**SEAS DEADLINE 6 RESPONSE to APPLICANTS's SUBMISSIONS**  
**SINCE DEADLINE 5, ISH3, Action Points and ExQ3**  
**LANDSCAPE & VISUAL and CULTURAL HERITAGE**

**PINS Ref:** EN020026  
**DEADLINE 6:** APRIL 13, 2026

# EN020026 SEA LINK DCO – DL6: RESPONSE BY NICHOLAS BRIDGES

## ZTV ANALYSIS – IP ref FA62B0DA

Figure 1. EN010077-001489-6.2.29.7 EAIN ES Figure 29.7 Onshore Substation ZTV (with landscape character)

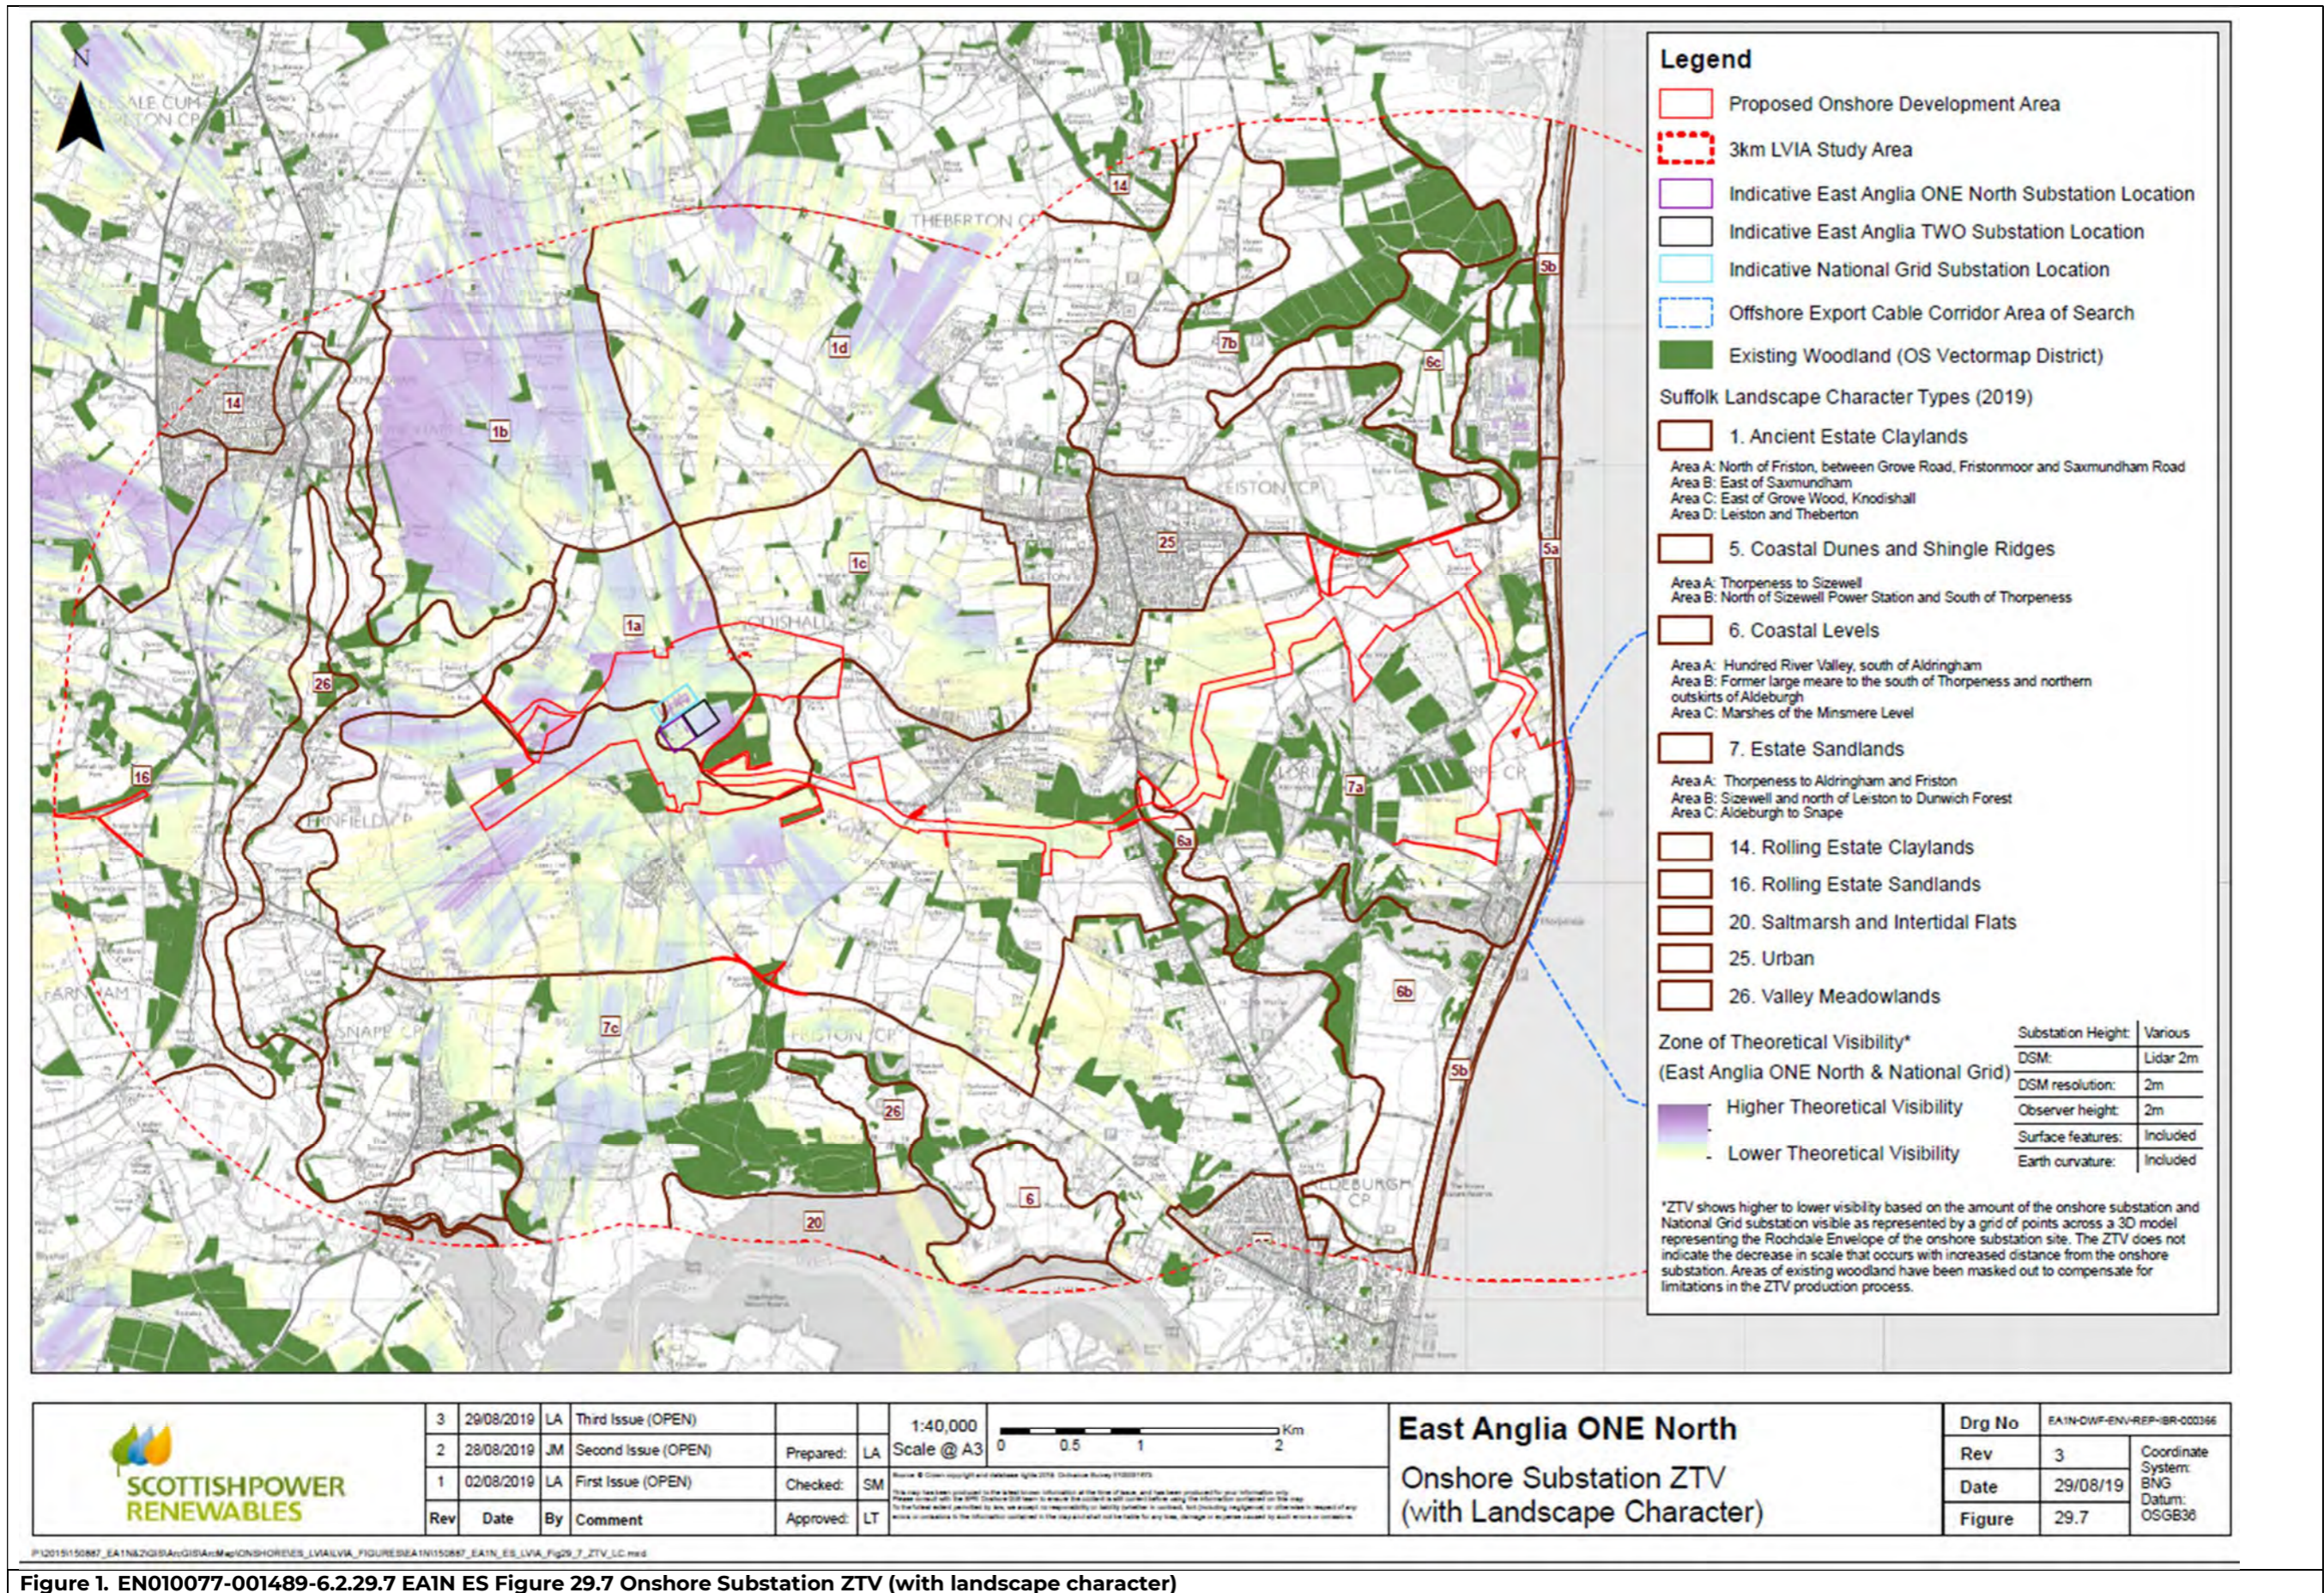
2.9. The ZTVs of the two Friston projects and Sea Link's PEIR have a similar pattern of visibility around their projects (see **Figures 1 to 11** below). Sea Link includes the National Grid substation at Friston which each of EA1N and EA2 also included. All Projects were modelled using OS contours, woodland and buildings at a generic height. Observer heights were a little higher for EA1N and EA2. The two Friston substations used the same parameter model as Sea Link.

2.17. The applicant does not seem aware of the EA1N and EA2 ZTV plans (**Figures 1, 2 and 3** below) which show that those developments would be visible. Nor the Sea Link PEIR likewise. Visibility from the top of the church tower is not relevant as the public have no access nor is it important as a private viewing point, unlike the Martello Tower for which this use was its primary function.
